# Access Compliance Report

## Public Rights-of-Way

| Intersection ID: 27561                  | Main Street: SKIPTON_LN | Cross Street: WHISPERING_WIND_DR        | Location: S            |
| ADA ID: D19C141548CF                    | Ramp Type: PerpDiag     | Initial Pass/Fail: Fail                 | Overall Compliance: No |

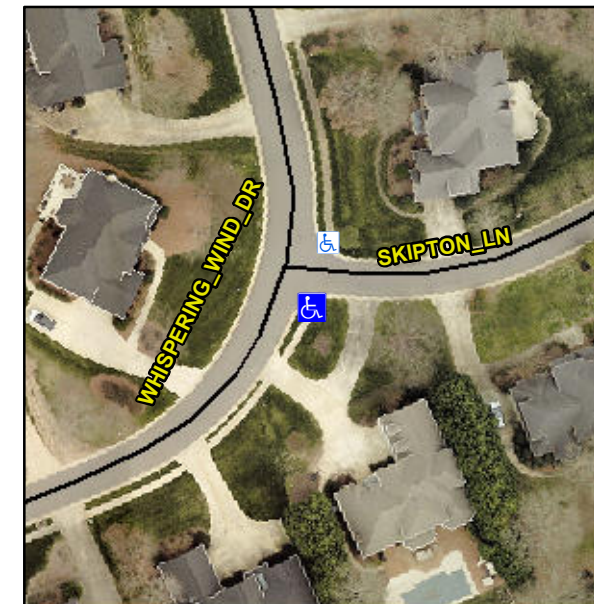
**R304.5.1, R304.5.3**

| Compliance | Description           | Data  | Compliance | Description                 | Data |
|------------|-----------------------|-------|------------|-----------------------------|------|
| No         | Ramp Width (in)       | 46.5  | No         | Ramp XSlope (%)             | 14.5 |

**Remove & Replace Curb Ramp With Two New Directional Ramps or Equivalent.**
